Resource Consent Application – Further information request

Application number: SP/0179/20
Applicant: 3MS Of Cambridge Limited Partnership
Address: 1881 Cambridge Road Cambridge 3434
Proposed activity(s): Subdivision to create 242 residential lots within the C2 Growth Cell, and associated lots for public assets

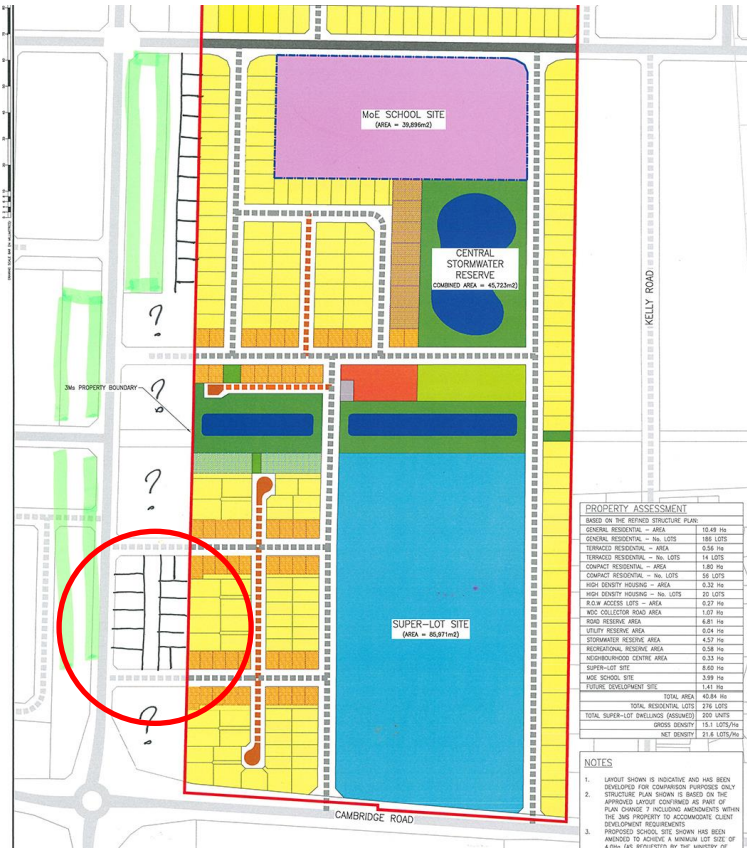
34. Integration of 3Ms site with adjoining land to the west

Issue:

Policy 15.3.1.1 of the district plan requires understanding of the constraints and opportunities of a site and the surrounding area to be understood by a site and area analysis. Development and subdivision are required to integrate with and acknowledge the constraints and opportunities of the site and surrounding area.'

The proposed layout within the 3Ms site on its western side, suggests that the adjoining land along the length of the western boundary of the site through to the north-south collector road (as shown to be repositioned in the 3Ms indicative Structure Plan) may not be able to be developed in a manner that would avoid significant use of rear lots, private laneways / JOALs, or single lot depth blocks with, for example, the collector road on the western side and a potential local road on the eastern side. The District Plan discourages rear lots and single lot depth blocks.

This raises the question of the suitability of this outcome on the adjacent land outside the site and what other outcomes may arise from the design approach proposed. No assessment with regard to policy 15.3.1.1 is provided.

At a Friday 19 March meeting with Abbie Fowler, Council's consultant urban designer, Matt Riley, shared his high-level thoughts as for how the land to the west might be developed by a landowner, presenting one option he has tested (see below – Red circle) that would produce undesirable urban design outcomes (eg: single lot depths) or, while potentially having vested north-south local roads, has doubtful viability. This is also an offsite effect.

- a. To assist the Council to consider the suitability of the layout of the proposal in this regard, please provide urban design analysis in this regard. The expected analysis should include indicative layout options for the adjoining land to the west of the 3Ms site, showing how it could be developed in a manner that minimises and ideally avoids the use of rear lots and private laneways.
